© 2009 Mazda Motor of America, Inc.

Subject: CHATTERING NOISE / UNABLE TO ADJUST DRIVER-SIDE MANUAL SEAT LIFT	Bulletin No: 09-059/09
	Last Issued: 10/23/2009

BULLETIN NOTE

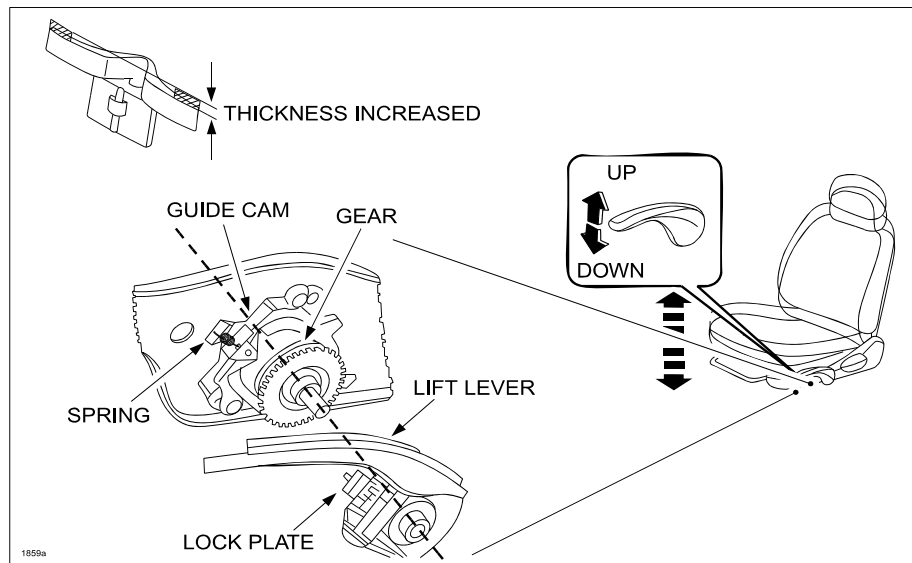
- This bulletin supersedes the previous bulletin 09-039/07 issued 11/21/07. The SUBJECT, APPLICABLE MODEL(S) / VINS and DECSRIPTION have been revised.
- Changes are noted below in Red beside the change bar.

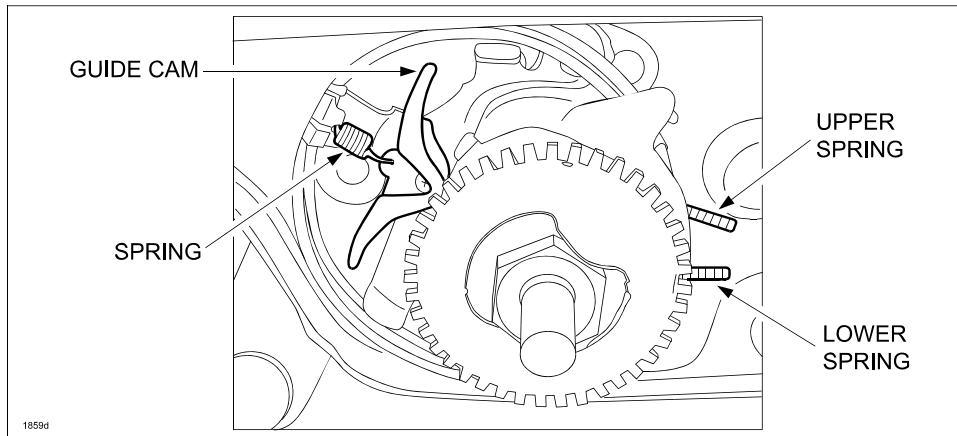
Some vehicles may exhibit a chattering noise and the driver-side seat lift cannot be adjusted because the lock plate guide comes off the guide cam when operating the lift. If the lift lever is then operated with the lock plate guide off, the guide cam can be damaged. The shape of both ends of the guide cam has now been changed to stop the lock plate guide from coming off.

6. Replace the guide cam and spring with modified ones.
 - a. Remove the spring and pull the guide cam outward to remove it from the shaft.

- b. Apply grease to the guide cam shaft and the contact surfaces of the guide cam and lock plate hook by reusing grease from the old part.
 - c. Replace the guide cam and spring with the modified ones.
